ATTACHMENT A

Beaver Valley Power Station, Unit No. 2
License Amendment Request No. 127

Beaver Valley Power Station, Unit No. 2
License Amendment Request No. 127
UPDATE HEATUP AND COOLDOWN CURVES AND OVERPRESSURE
PROTECTION SYSTEM (OPPS) SETPOINT CURVE

FIGURE 3.4-2

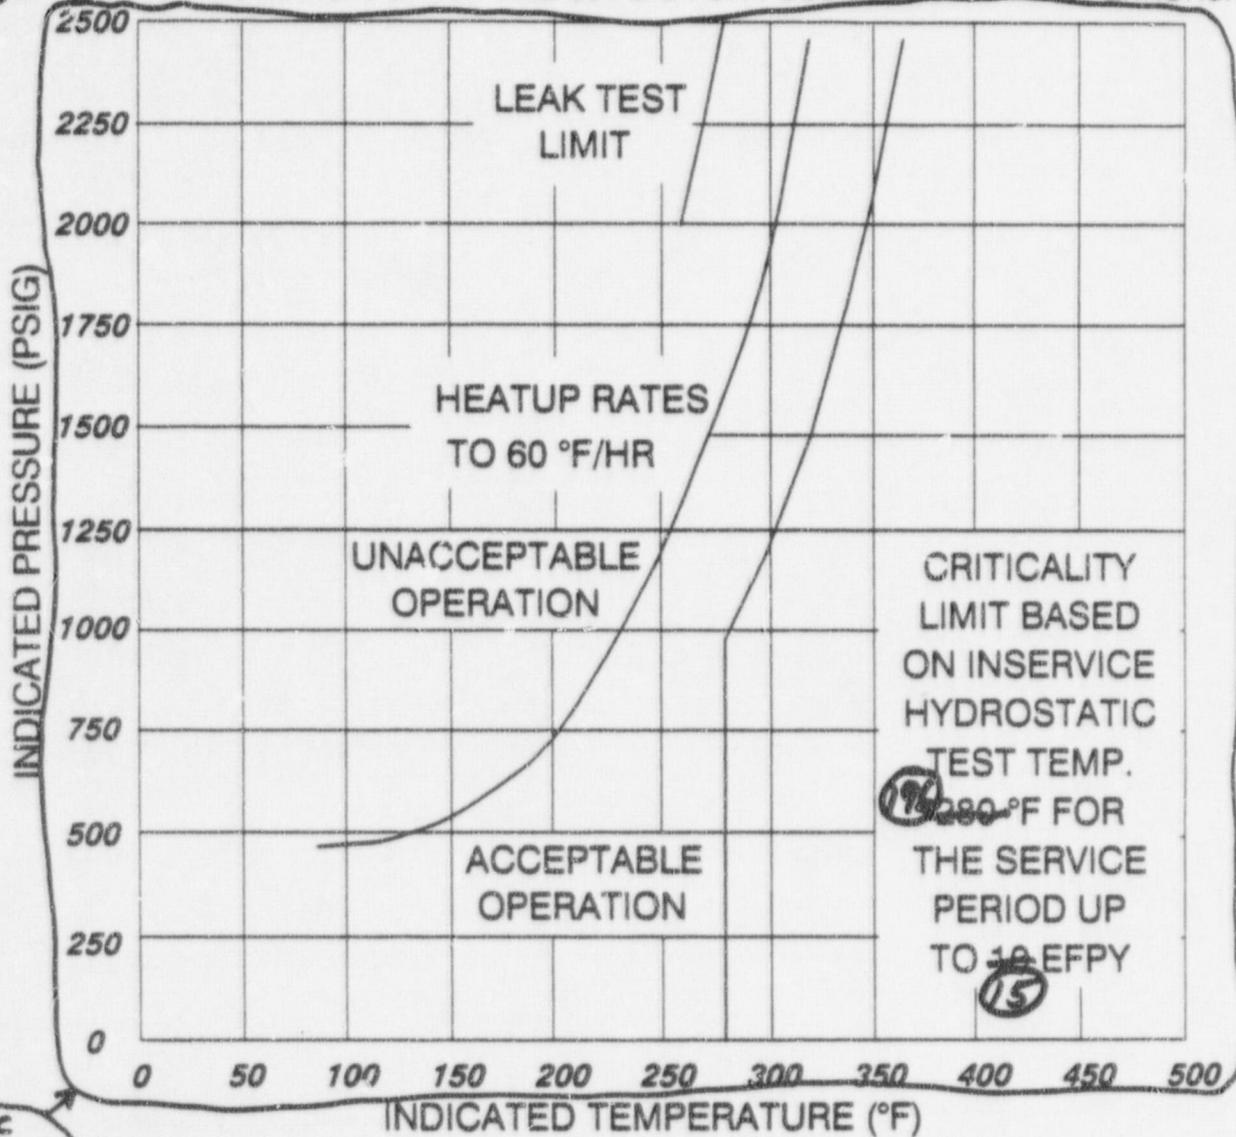
CURVES APPLICABLE FOR HEATUP RATES UP TO 50°F/HR FOR THE SERVICE PERIOD UP TO 10 EFPY. CONTAINS MARGIN OF 10°F AND 20 PSIG FOR POSSIBLE INSTRUMENT ERRORS.

INSERT A

FIGURE 3.4-3
 Beaver Valley Unit 2 Reactor Coolant System Cooldown
 Limitations Applicable for the First 10 EFPY (15)

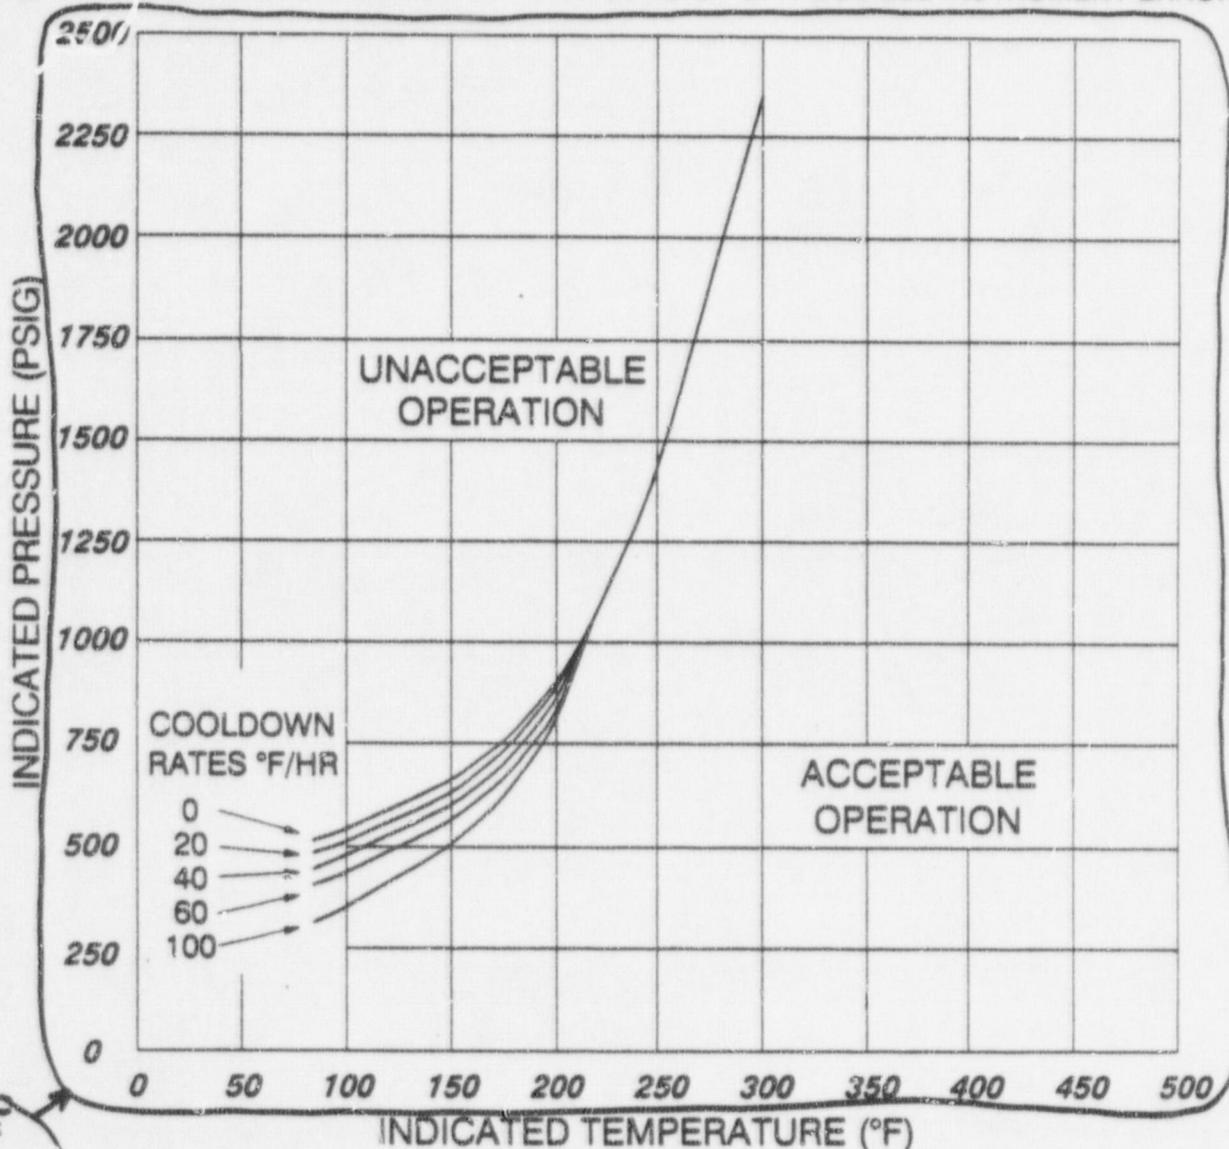
REPLACE WITH INSERT B

Separate each cooldown rate into a separate figure, i.e., (a, b, c, d and e)

FIGURE 3.4-4

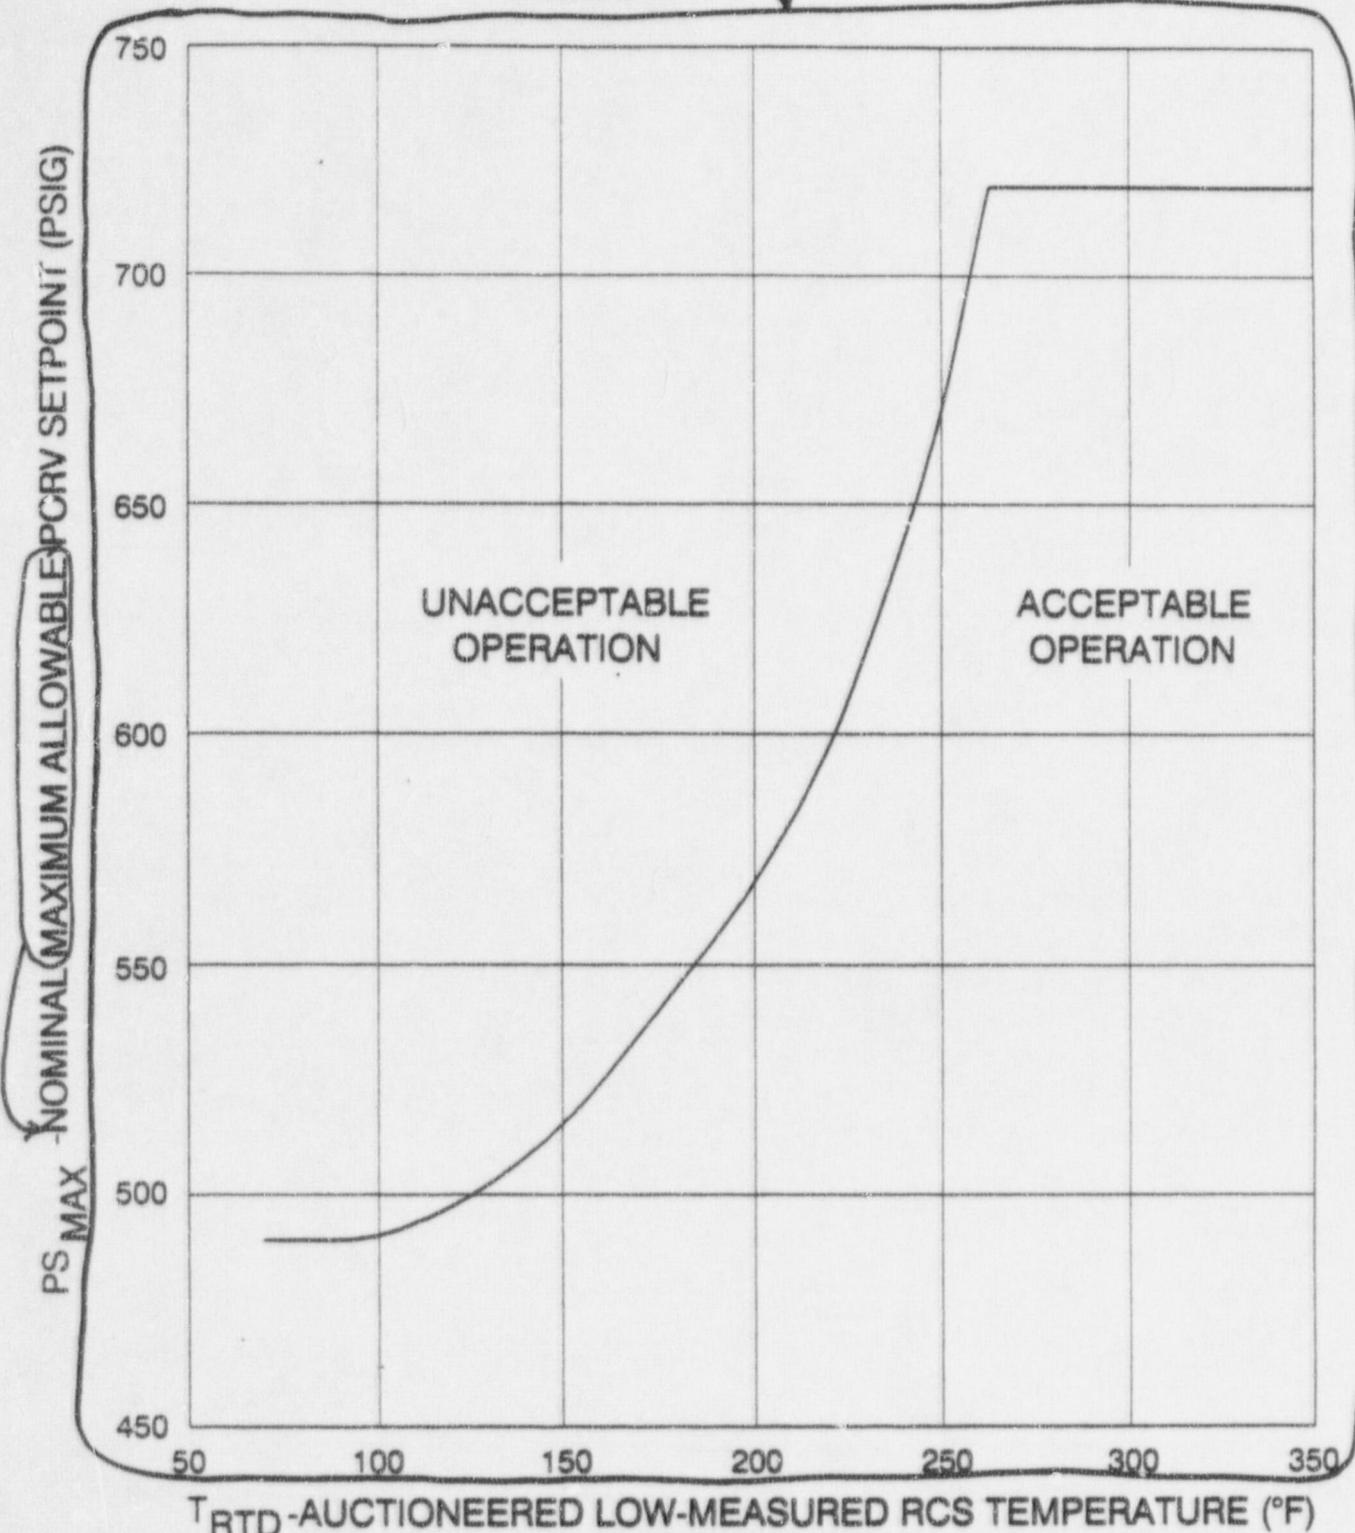
REPLACE WITH INSERT C

FIGURE B 3/4 4-1
FAST NEUTRON FLUENCE (E>1 Mev) AS A FUNCTION
OF FULL POWER SERVICE LIFE (EFPY)

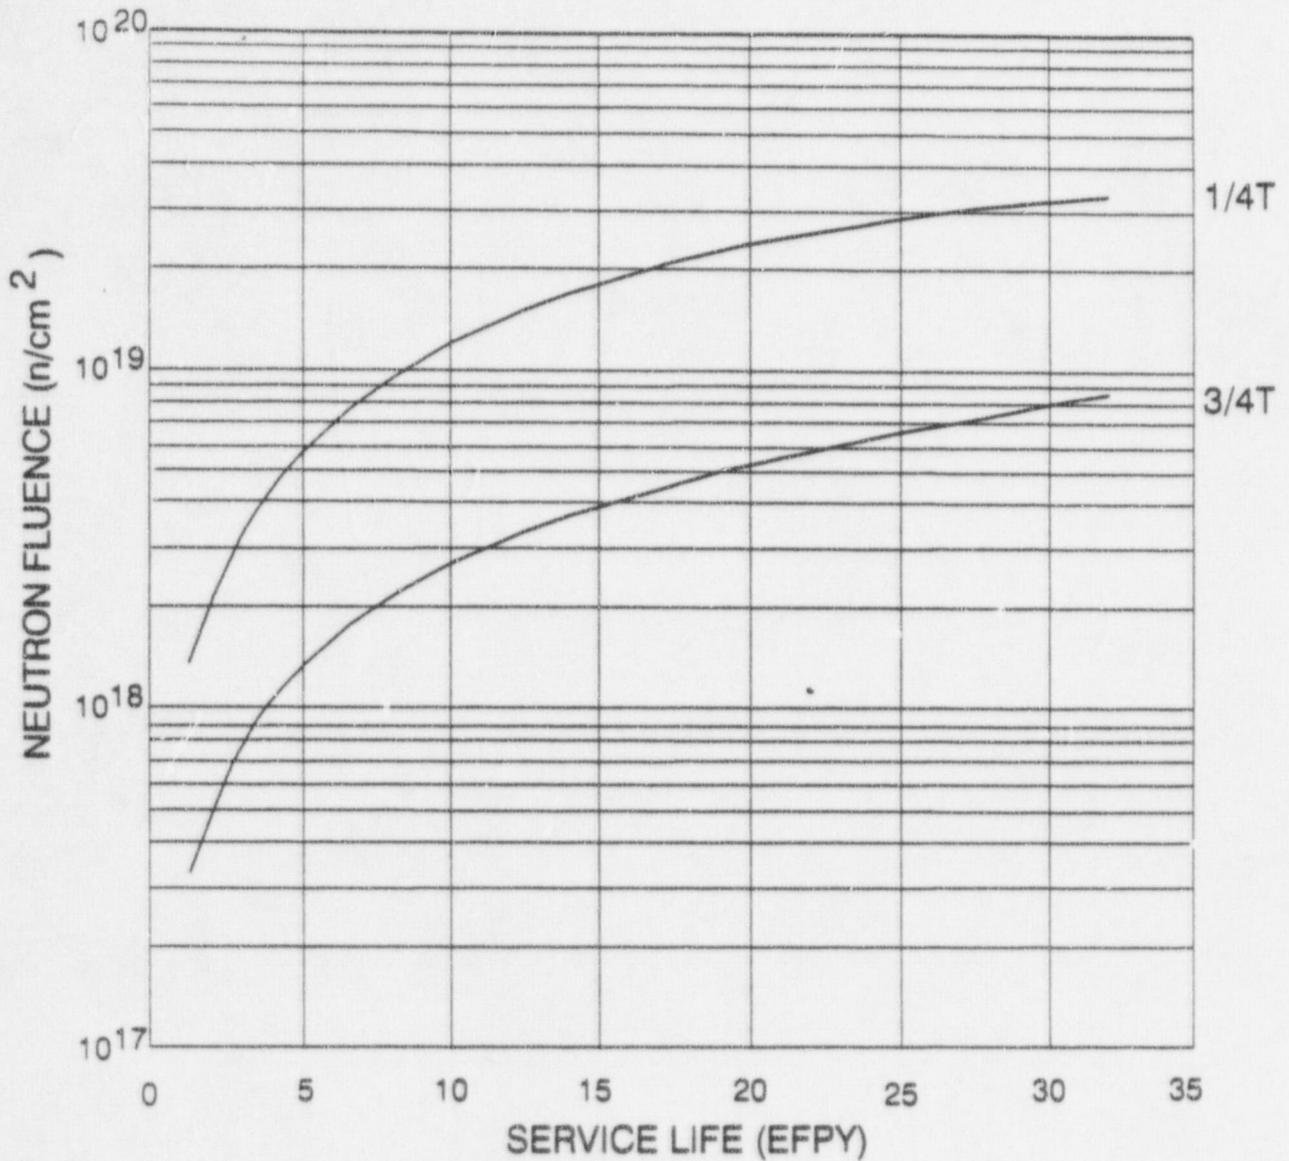
B 3/4 4-9
 (Delete this page)

INSERT D

FIGURE B 3/4 4-3 ← 2

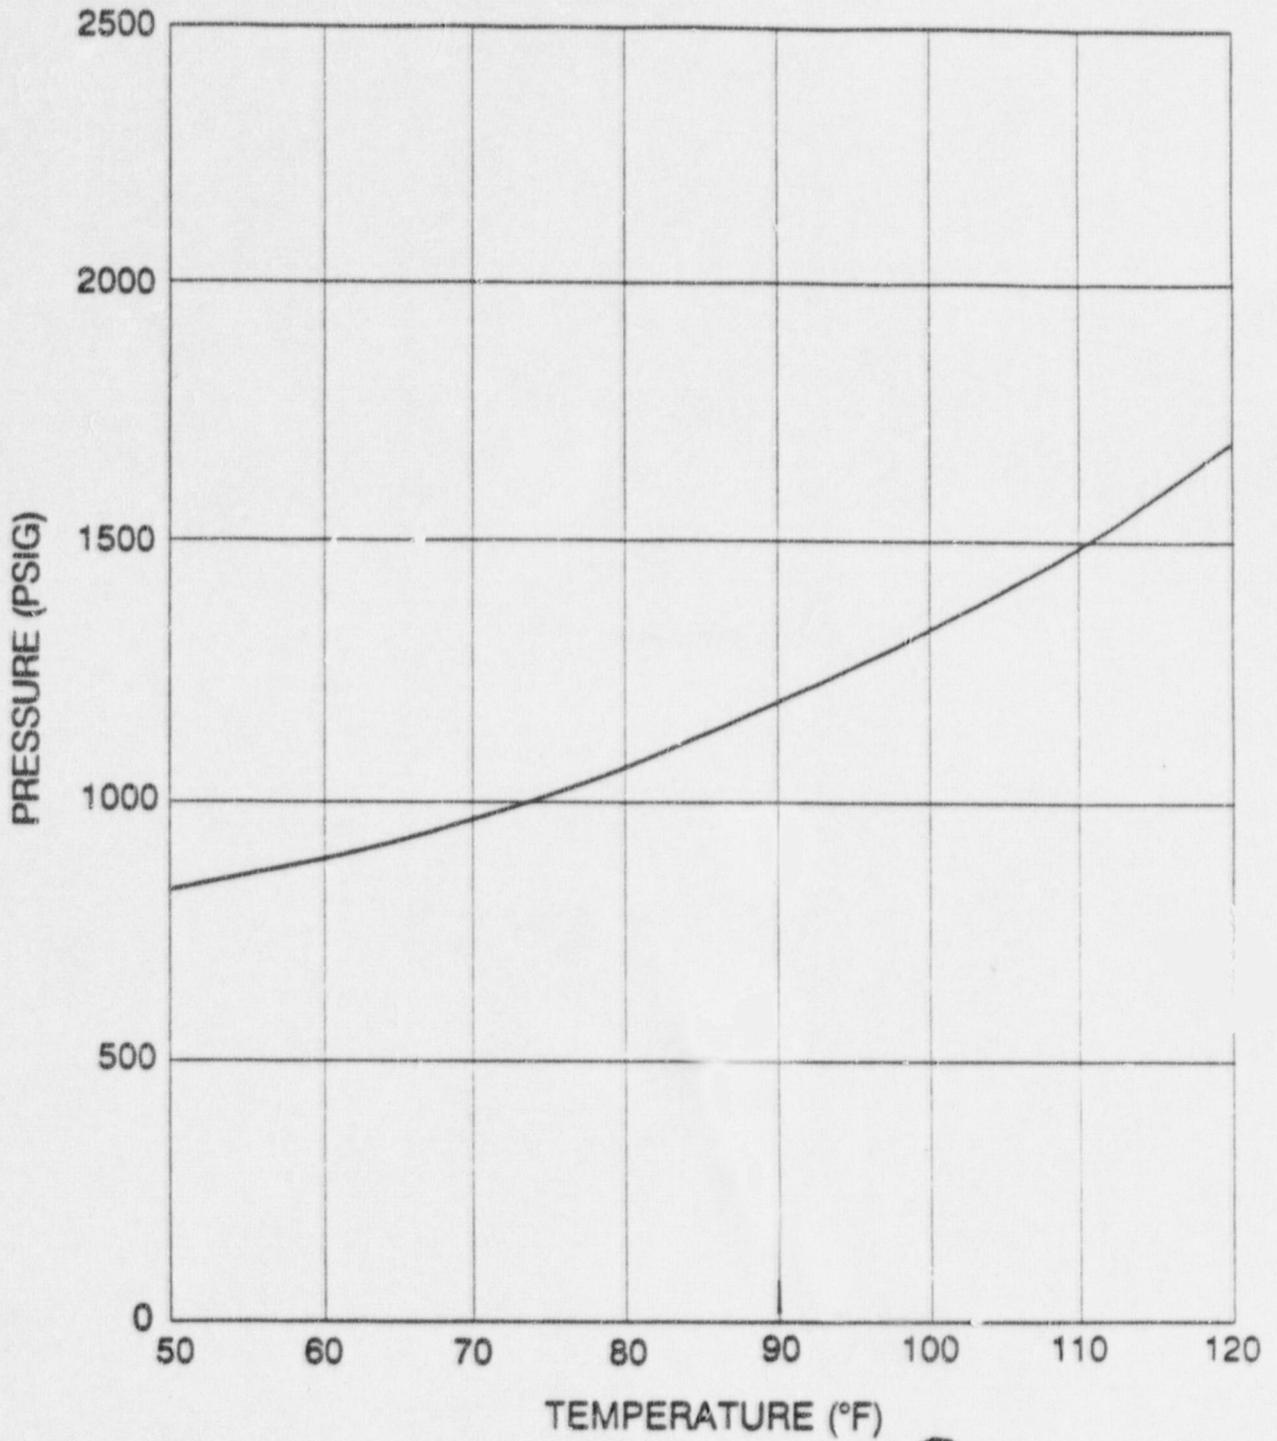
Pressure-temperature limit curves shown in figure B 3/4 4-2 were developed for the limiting ferritic steel component within an isolated reactor coolant loop. The limiting component is the steam generator channel head to tubesheet region. This figure provides the ASME III, Appendix G limiting curve which is used to define operational bounds, such that when operating with an isolated loop the analyzed pressure-temperature limits are known. The temperature range provided bounds the expected operating range for an isolated loop. and Code Case N-640
